# ***FINAL ENVIRONMENTAL IMPACT REPORT***

## ***10000 Santa Monica Boulevard Project***

***ENV-2011-0540-EIR***

**January 2012**

**FIGURE 1**  
**10000 Santa Monica Project**  
**Sewer Map**

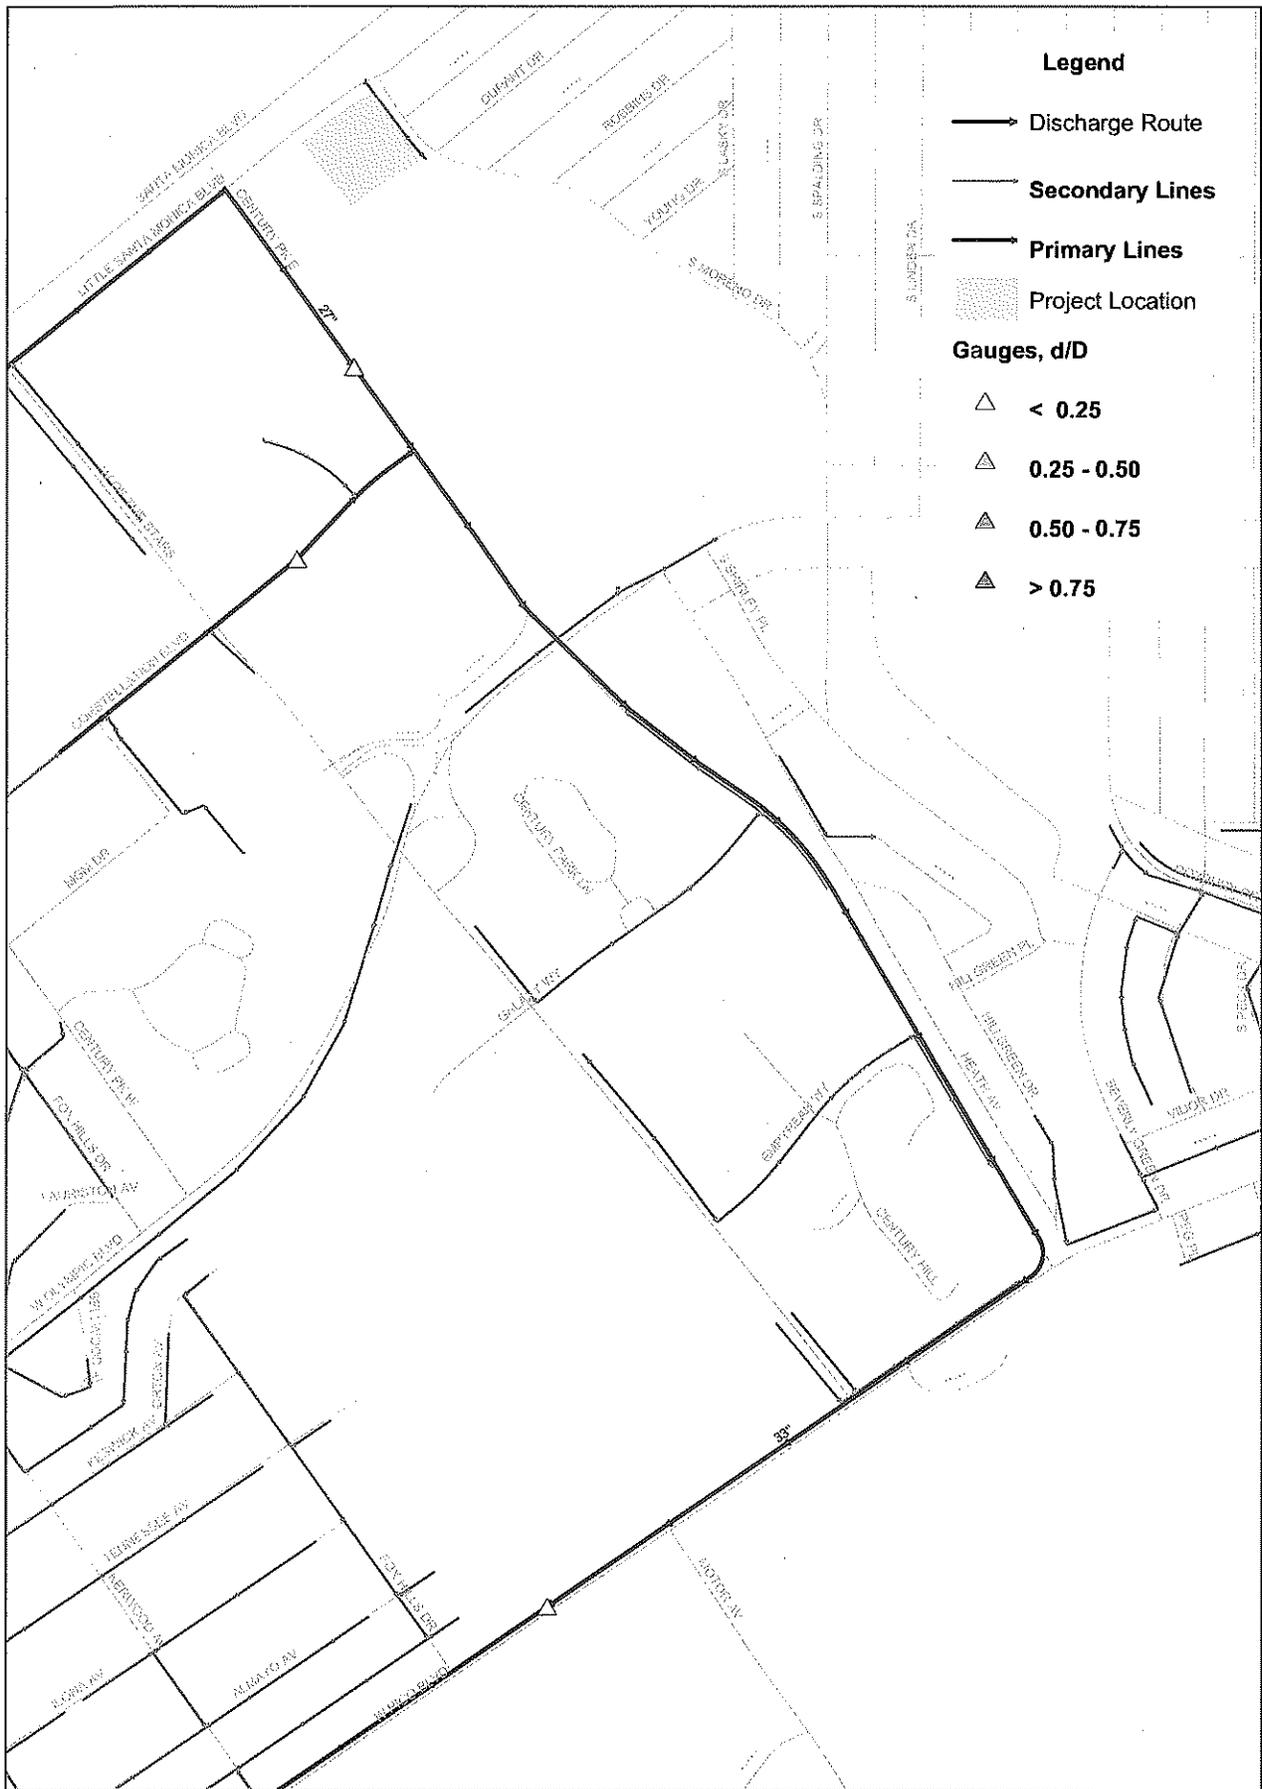
The sewer infrastructure in the vicinity of the proposed project includes an existing 27-inch line on Century Park East. The sewage from the existing 27-inch line discharges into a 33-inch sewer line on Pico Blvd. Figure 1 shows the details of the sewer system within the vicinity of the project.

**FIGURE 1B**

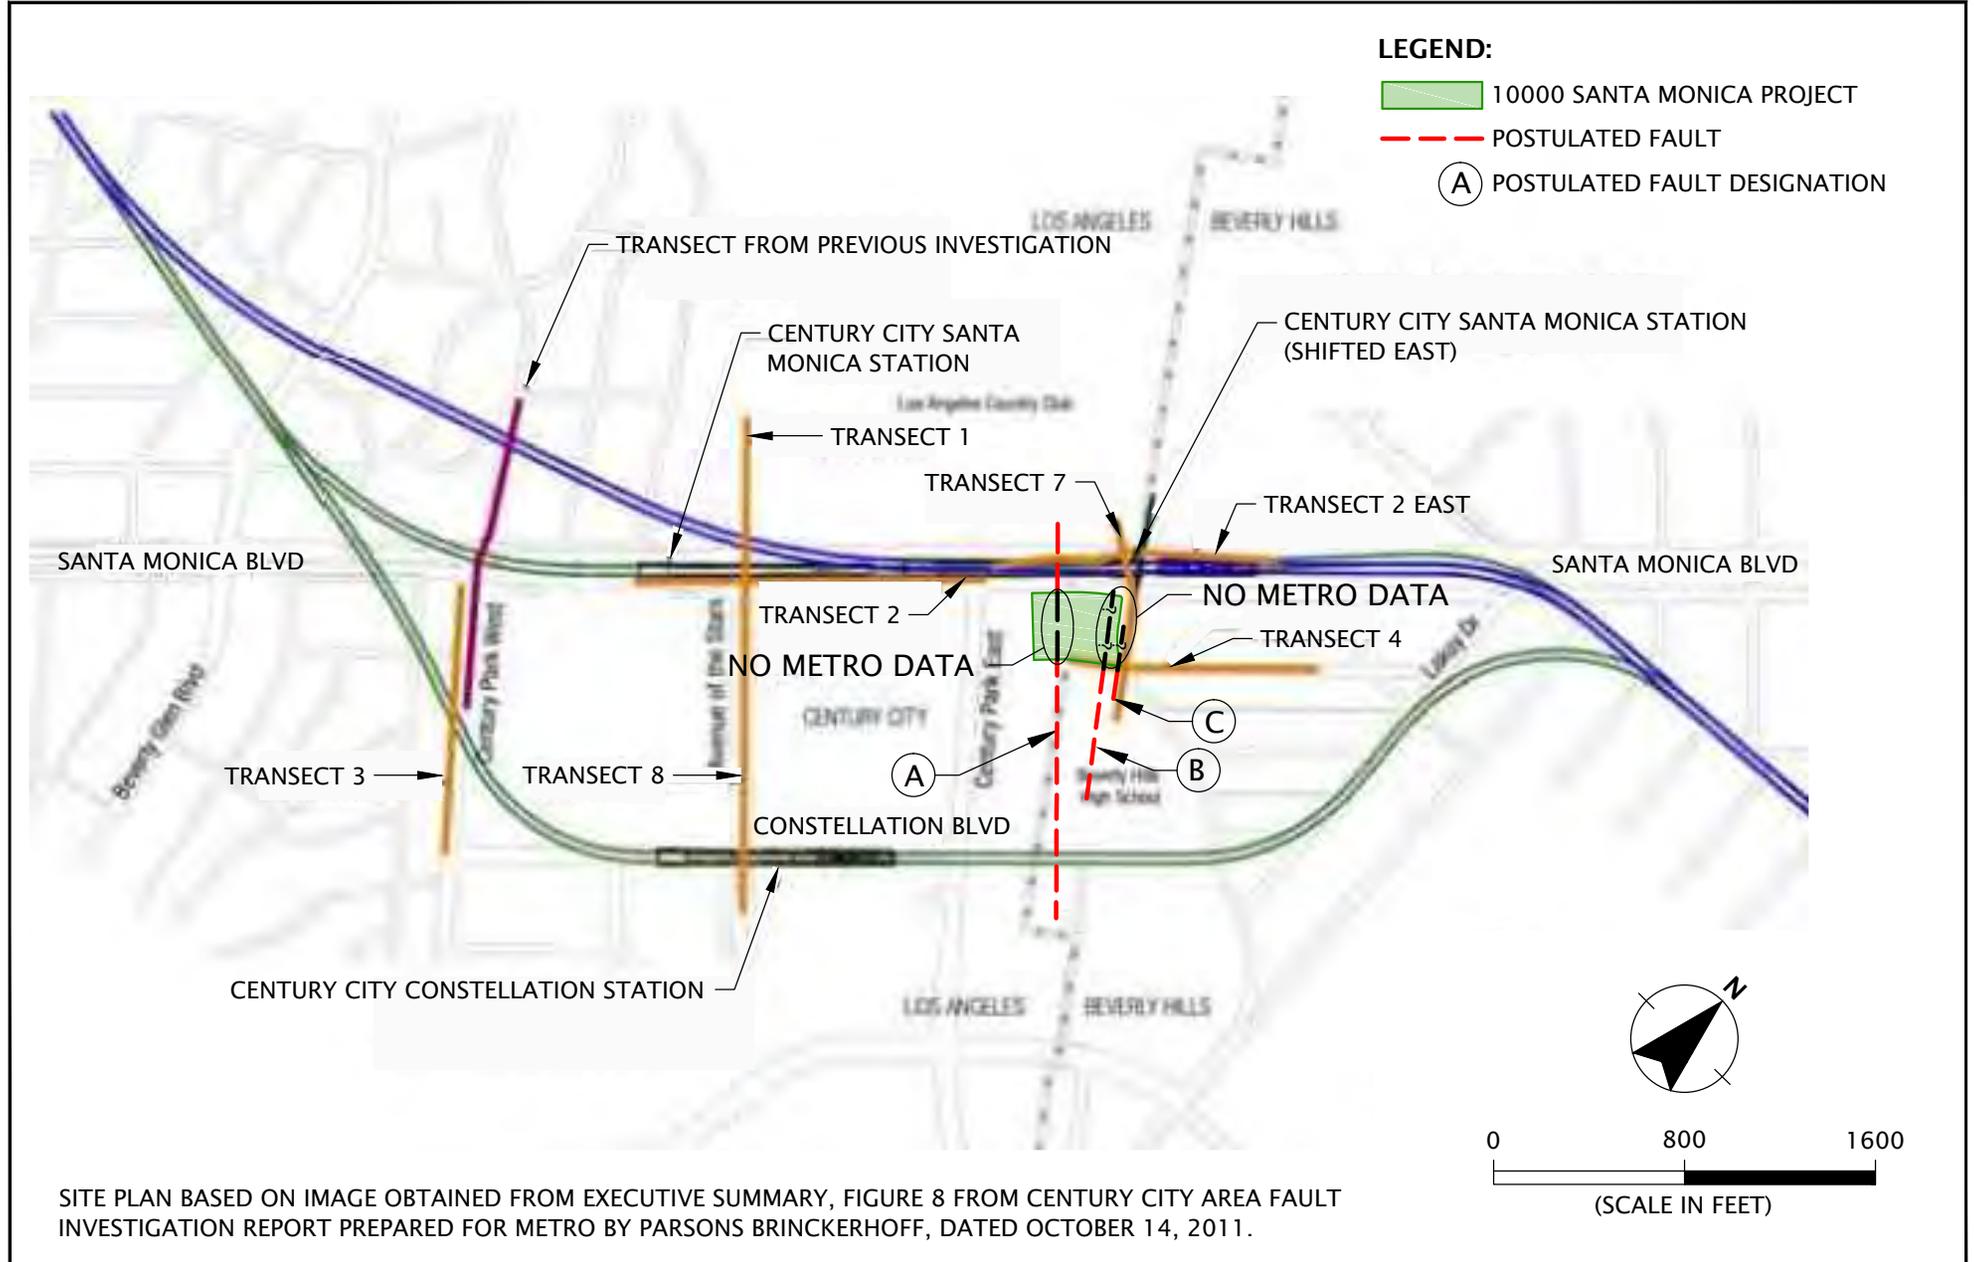
While METRO's graphic presented in their Fault Investigation Report does not query these faults, these faults are queried on the graphics prepared by AMEC, METRO's geotechnical consultant that performed METRO's Fault Investigation. Figure 1B, AMEC's Fault Zones, shows AMEC's queried fault locations.

2121 S Towne Centre Place - Suite 130 Anaheim CA 92806 Off 714.634.3701 Fax 714.634.3711	CRESCENT-1-01	<b>TRANSECT 2E SEISMIC SECTION INTERPRETATION</b>	
	DECEMBER 2011	PROPOSED TOWER DEVELOPMENT LOS ANGELES, CA	<b>FIGURE 4</b>

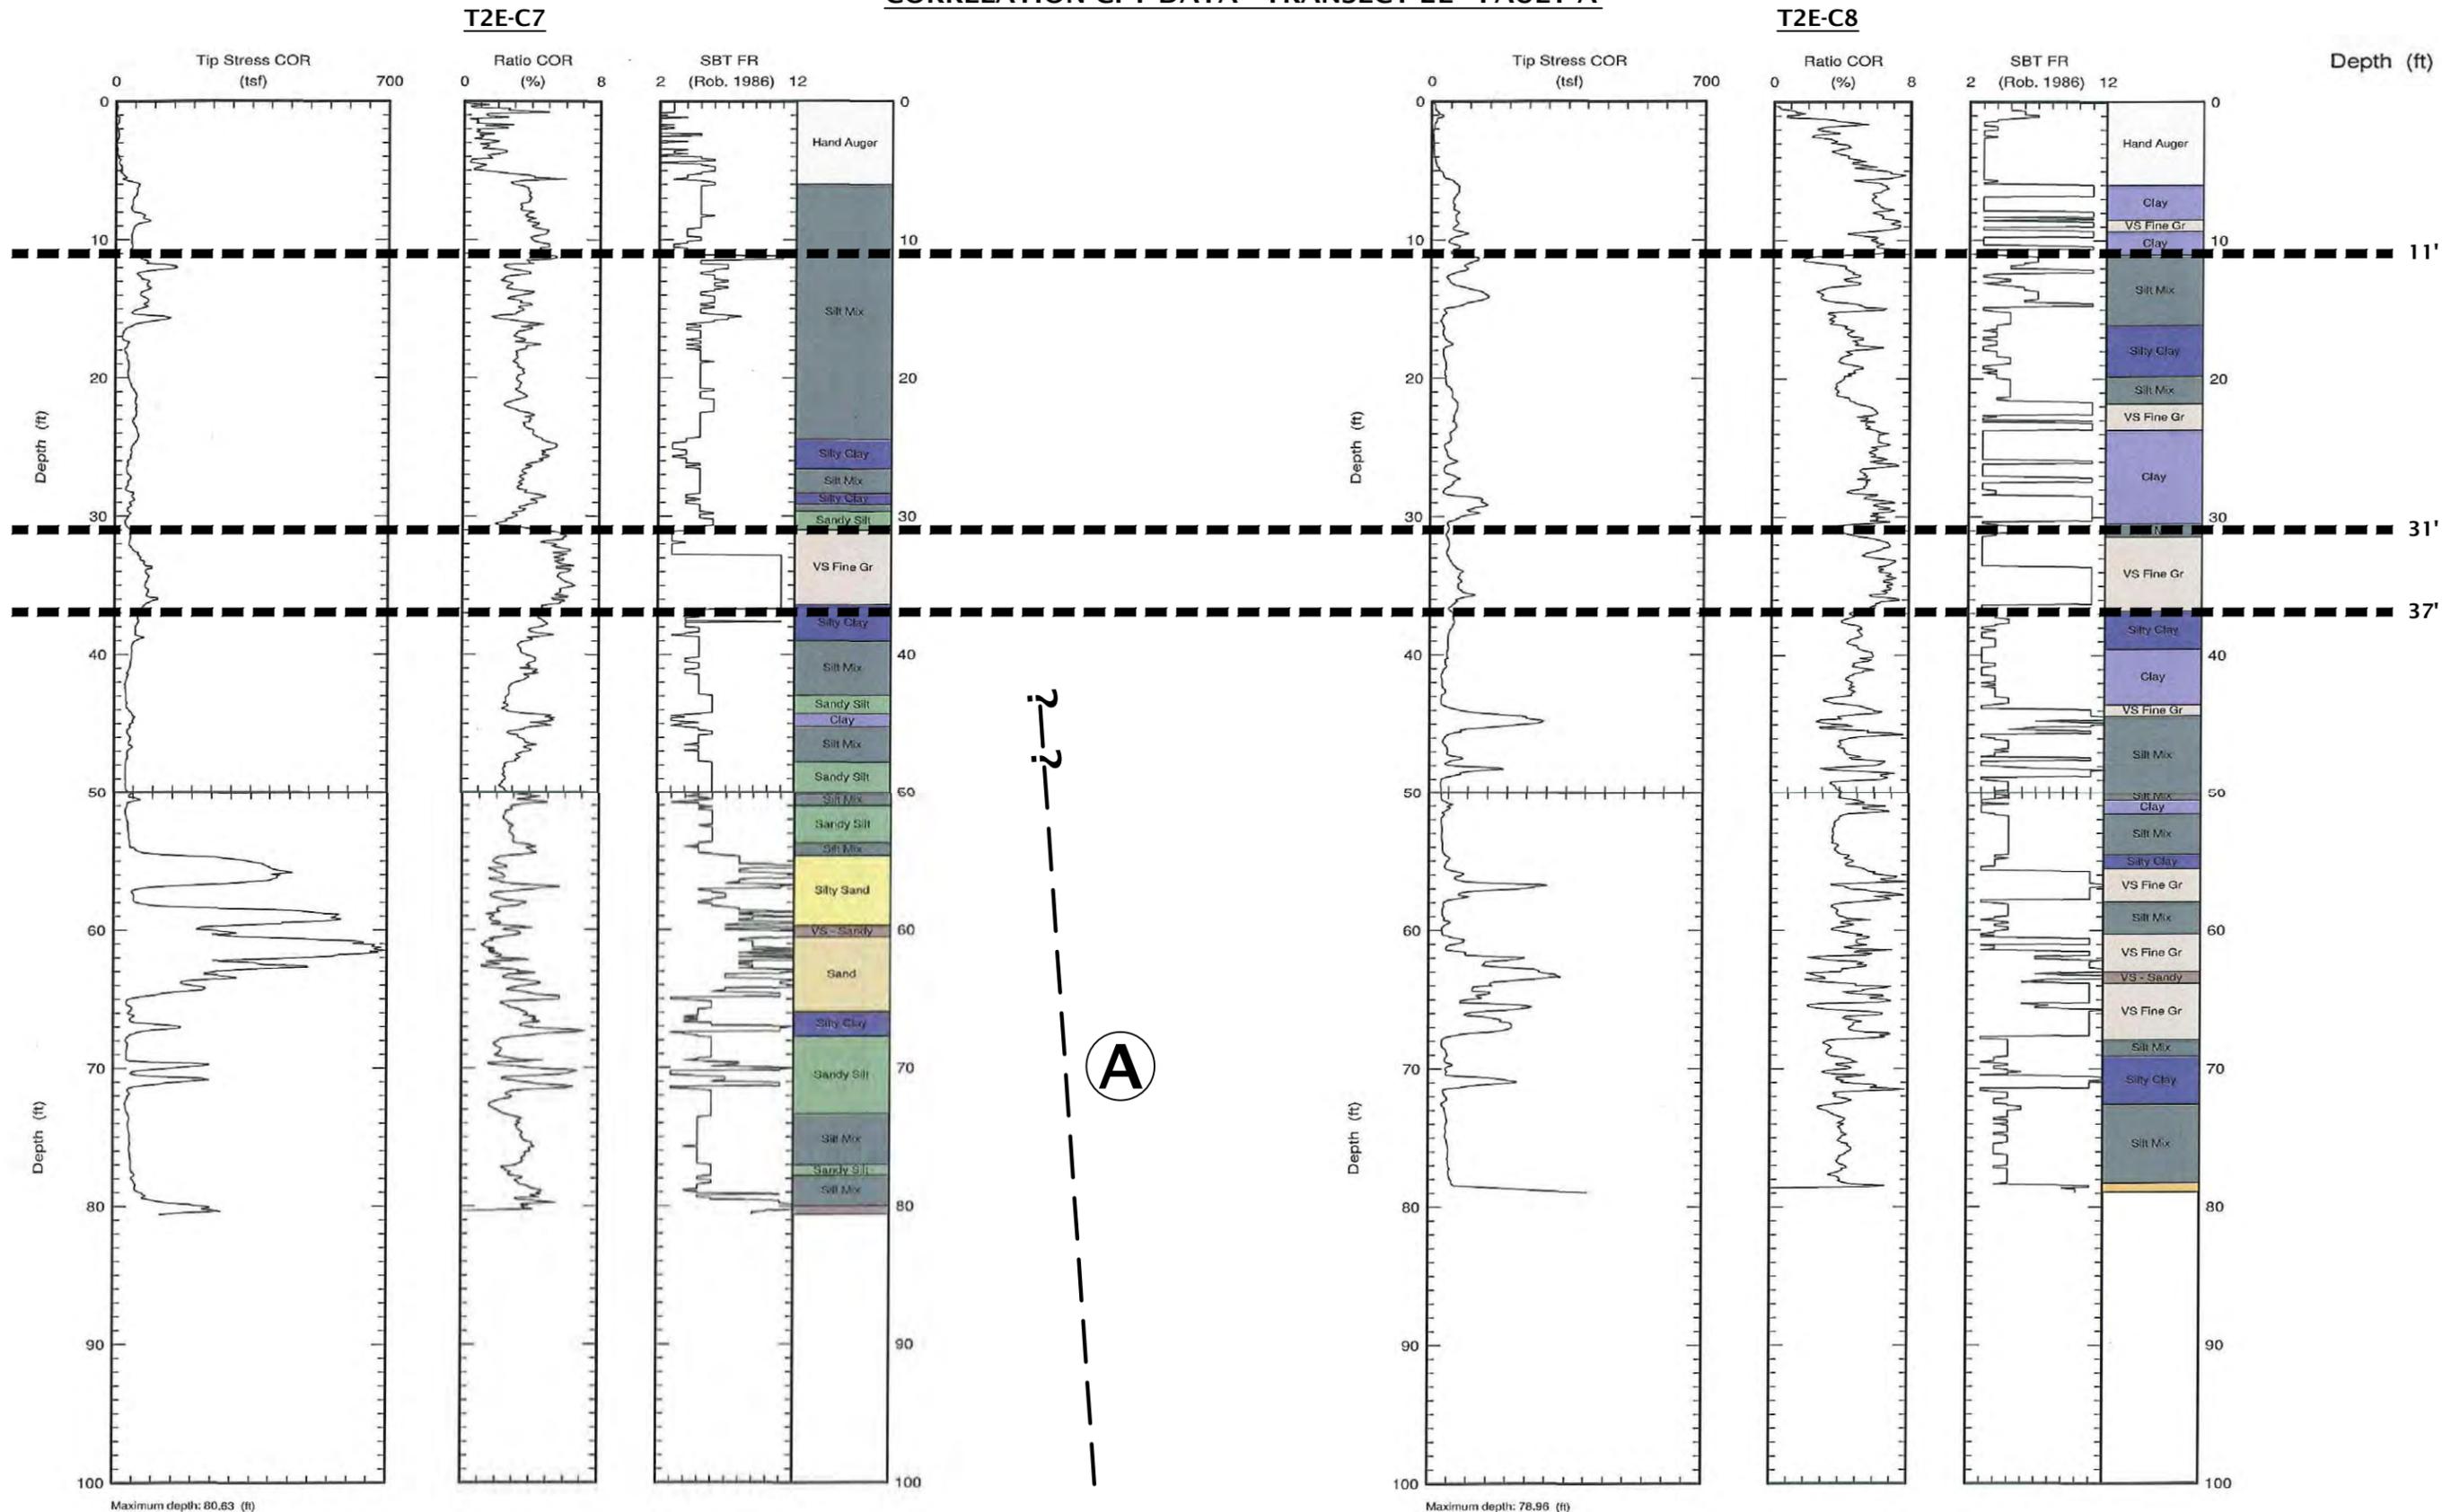
Postulated Fault A is identified along Transect 2E at depths greater than 80 feet BGS based on METRO's correlation of stratigraphic units in borings T2E-B2 (drilled to 161 feet BGS) and T2E-B3 (drilled to 200 feet BGS), which are spaced 250 feet apart along Santa Monica Boulevard. The locations of these borings are shown on Figure 3, METRO Transect 2E (METRO's Figure L-6). Fault A is also interpreted by METRO to be present below a depth of approximately 35 feet BGS based on analysis of the seismic reflection data as shown on Figure 4, Transect 2E Seismic Section Interpretation (METRO's Figure 21 of Appendix D).
